**From:** Eric Roth <[REDACTED]>  
**Sent:** Tuesday, August 28, 2018 7:32 PM  
**To:** jeffrey E.  
**Subject:** RE: Sub woofer

The aircraft was designed with four (4) sub woofers:

Mounts to the floor

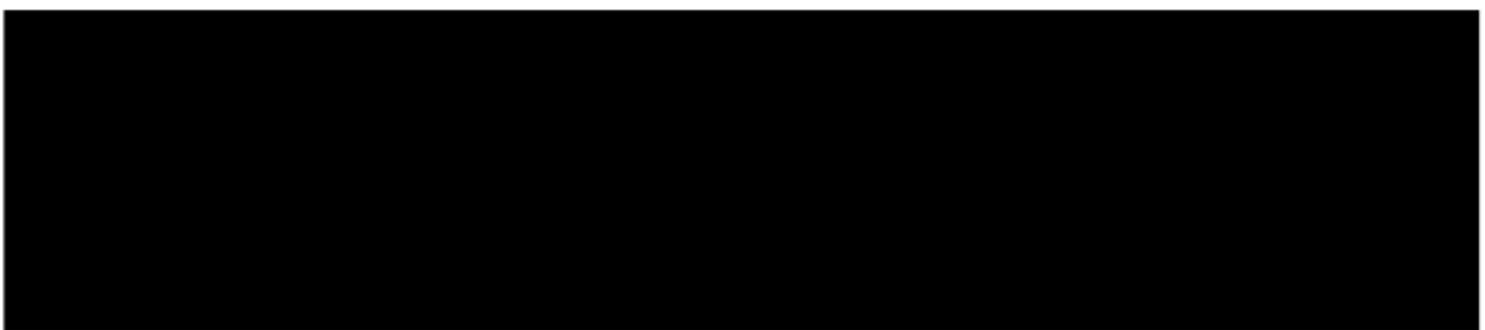
The Dennis Tracey subs are designed to require very little air movement (see photos below).

There is a foam membrane to "seal" the sub with the only area for air movement is approx.. .50" high x 2.00" wide (either side of the one mounting bracket)
